**Flood Control Project Maintenance  
Levee Inspections**

## Maintenance Issue Types Only, Levee Inspection Report By Mile - Fall 2019

### Reclamation District No. 0765 Glide

Waterway	Bank	Unit Miles	Inspection Start/End	Inspector
Unit No. 01 Sacramento River	Right	1.72	11/12/2019 11/12/2019	Luz Dial

Photo 1 of 1 : FA\_2019\_RD0765\_211\_1\_20190904\_00001.jpg

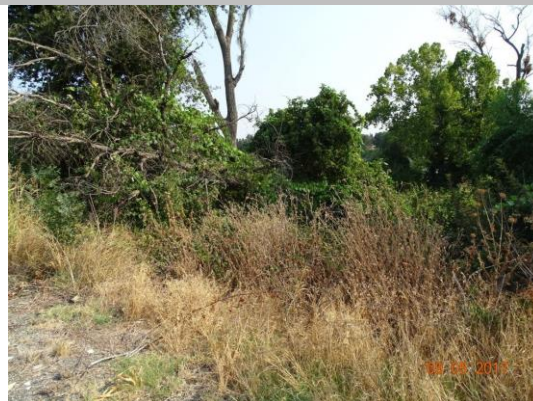
LM Start	1.58	Rating **	M	Issue No.	1
LM End	1.58	Issue Type +	Ma	Location *	WS
Category	Earthen Levee			GPS Latitude/Longitude	
				Start	End
Item	Encroachments			38.481959 °	38.481959 °
				-121.550527 °	-121.550527 °
DWR ID	DWR_RD0765_01_f_2017_1				
Comment Code					
TR : Tree or limb					
Inspector Comment					
Remove fallen tree on waterside slope.

View looking north at the fallen tree. Fall 2017
